RESPONSE TO NRC LTR DTD 04/07/78... FORWARDING ANSWERS TO THE CYCLE 4 RELOAD
QUESTIONS AND ADDL CONCERNS AS REQUESTED BY NRC.

PLANT NAME: THREE MILE ISLAND - UNIT 1

April 10, 1978
GQL 0658

Three Mile Island Nuclear Station, Unit 1 (TMI-1)
Operating License No. DPR-50
Docket No. 50-289

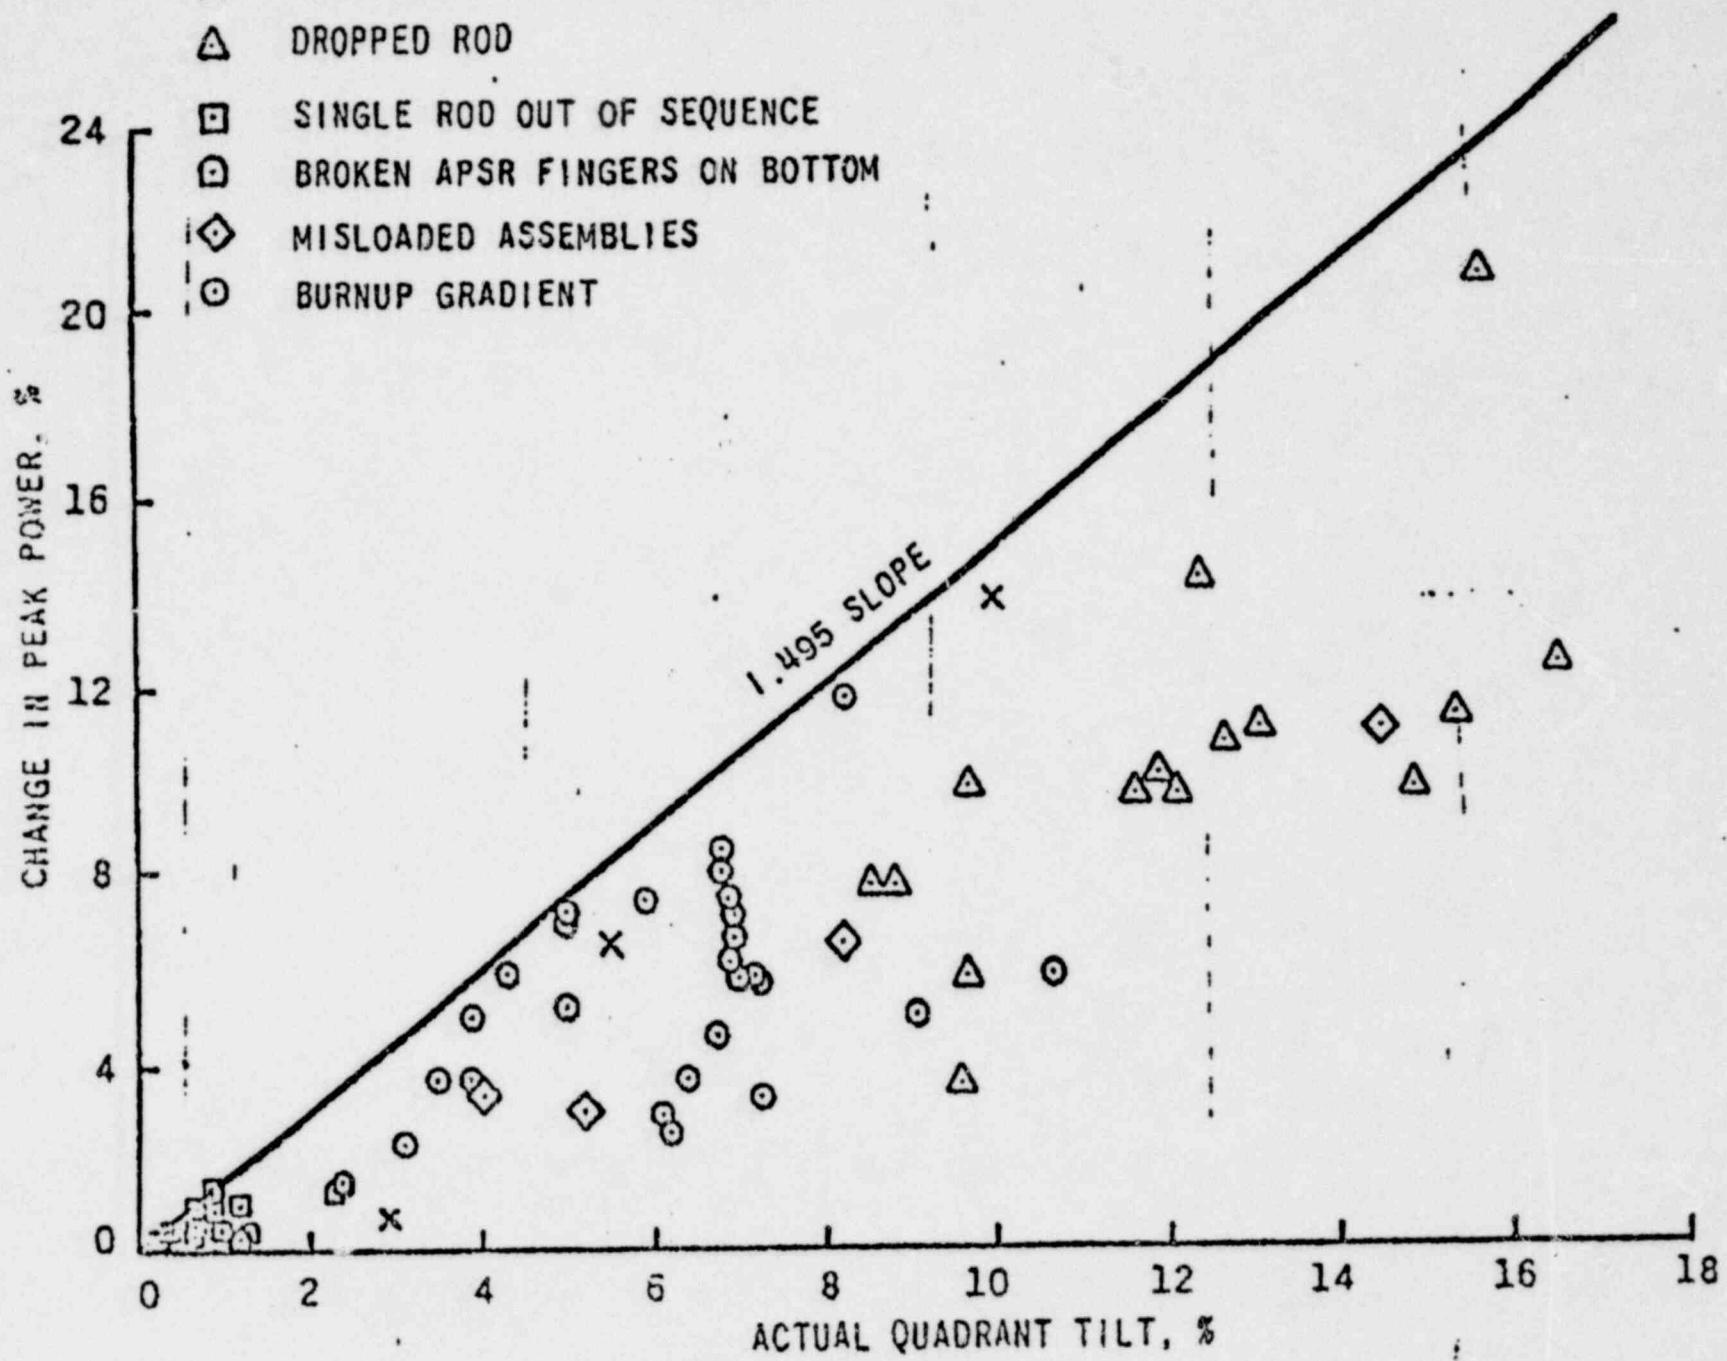
Provide an explanation of the increase in quadrant tilt from 3.41 to 4.92% being proposed in the Technical Specifications. What kind of a penalty is taken in the calculation of peaking factors in order to account for the allowable 4.92% tilt? Provide the basis for the adequacy of this penalty.

The data on calculated power peak increase due to quadrant power tilt are presented in the attached figure. These data are from both Figure 3-5 of BAW-10078 and recent investigations of the Oconee I, Cycle 4 tilt behavior. The following discussion characterizes the method of tilt inducement used in the various calculations.

Following the legend in the attached figure, the first tilt type considered was that due to multiple rods out of sequence (symbol x). Two of these values are from Figure 3-5 of BAW-10078, and one from recent 3-D FLAME investigations of potential Oconee I multiple misaligned rods. These three represent from 2-6 rods misaligned. In the Oconee I case, rods in diagonally opposite quadrants were moved in opposite directions. The core was modeled with 24 axial nodes of 6" each. Bank 7 was misaligned such that one rod (on a minor axis) was one node above the bank average and the diagonally opposite rod was one node below the bank average.

The next type of tilt, shown with the symbol Δ , was that caused by a dropped rod. In addition to the four cases from Figure 3-5 of BAW-10078, eleven additional cases were calculated for the Oconee I, Cycle 4. Every potential dropped rod location, including those on the major axes, was investigated.

The third tilt type was that caused by a single rod out of sequence (symbol \square). These ten cases were as reported in BAW-10078. The results are all clustered at low tilt and peak increase values. These were 3-D PDQ07 cases.

The fourth tilt type shown (symbol \square) was that due to various numbers of individual APSR fingers (1-3) assumed to be broken off and resting on the bottom in three different assembly locations. Three-dimensional FLAME calculations for the beginning of Oconee I, Cycle 4 were run at 40% FP, and without xenon, to amplify peaking effects.

The fifth tilt type was generated assuming several (3-6) misloaded assemblies (symbol \diamond). Enrichment deviations of from $\pm .01$ w/o (6 locations) to $-.90$ w/o (3 locations) were investigated. Again, the beginning of Cycle 4 of Oconee I was the configuration analyzed.

The sixth and final tilt type investigated (symbol θ) was that caused by a non-symmetric burnup distribution in two fuel batches being carried over into Cycle 4 of Oconee I. Partial results of these calculations are given in BAW-1477. FLAME was used to simulate an end of Cycle 3 burnup asymmetry of +2% in one core quadrant and -2% in the diagonally opposite quadrant. The fuel was then shuffled into the Cycle 4 pattern and depleted in full core geometry to 50 EFPD. The power level was set at 40% FP to 4 EFPD, at 75% FP from 4 to 23 EFPD, and a 100% FP from 23 to 50 EFPD. A total of 26 variations of power level and burnup supplied data for the points plotted.

As can be observed from the figure, all of the over 60 data points fall below the line which has a slope of 1.495. This was the value assumed in assigning a 7.36% peak increase to an allowable tilt of 4.92% for the TMI-1, Cycle 4 Technical Specification.
